ORIGINATION FORM

Proposed Revisions to a Design Standards Index (Please provide all information – Incomplete forms will be returned)

Date: March 8, 2017 Originator: **Derwood Sheppard** Phone: (850) 414-4334 Email: Derwood.Sheppard@dot.state.fl Index Number: **310** Sheet Number (s): 1 of 2 Index Title: Concrete Sidewalks

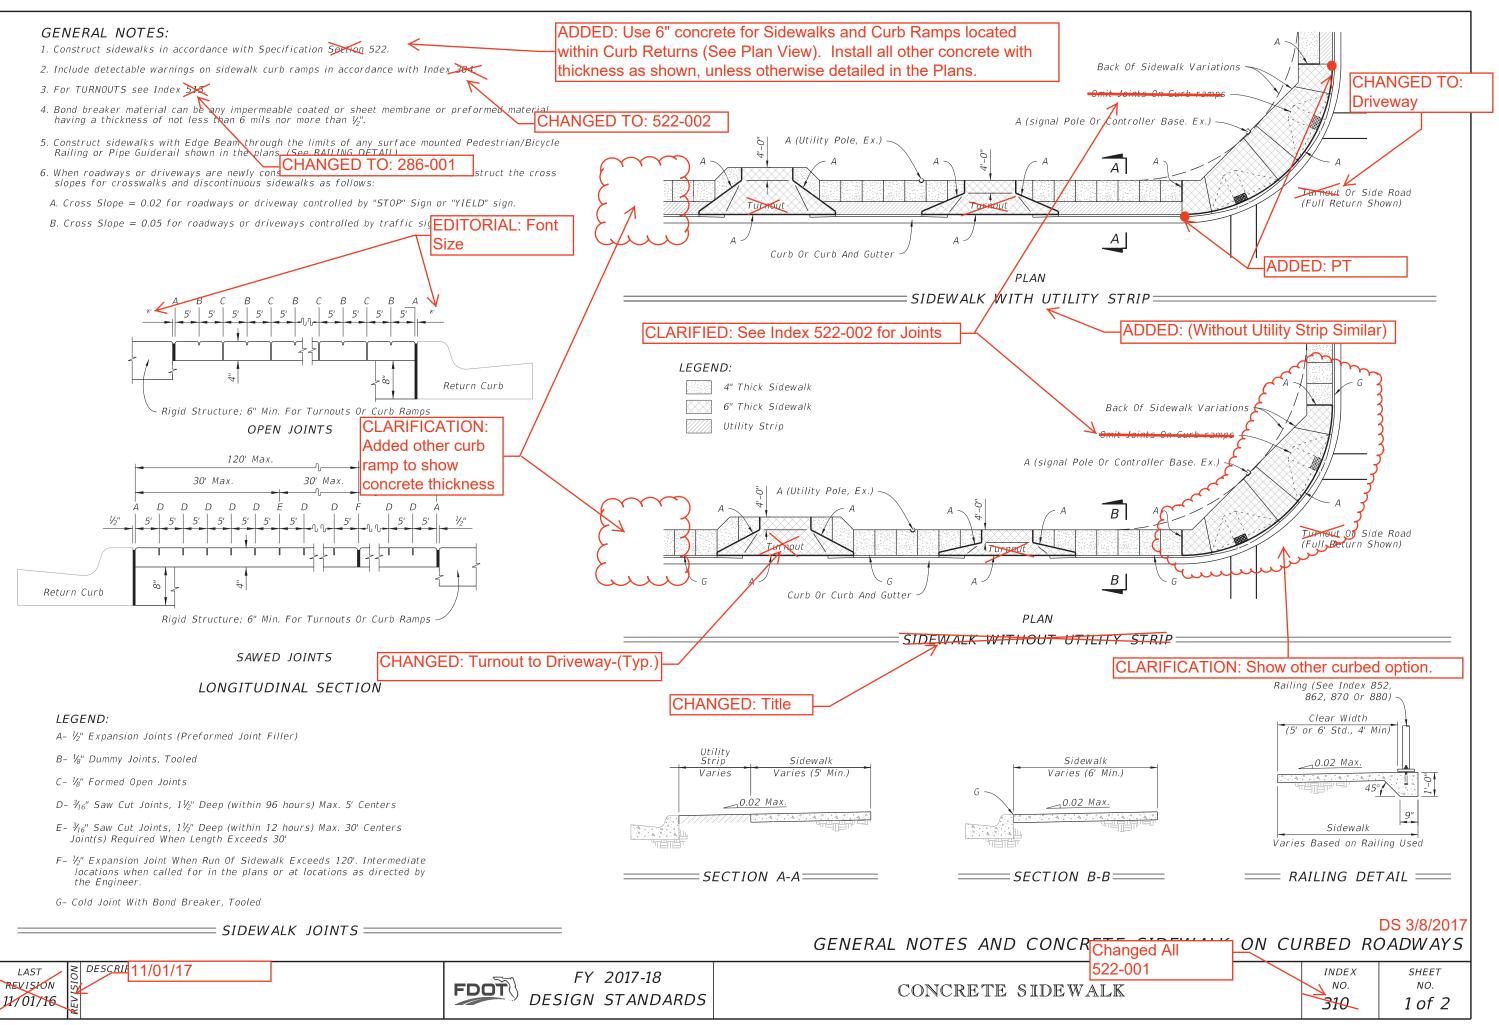
Sheet 1: Clarified Joints in the Curb Ramps in the call outs in the SIDEWALK Plan views.
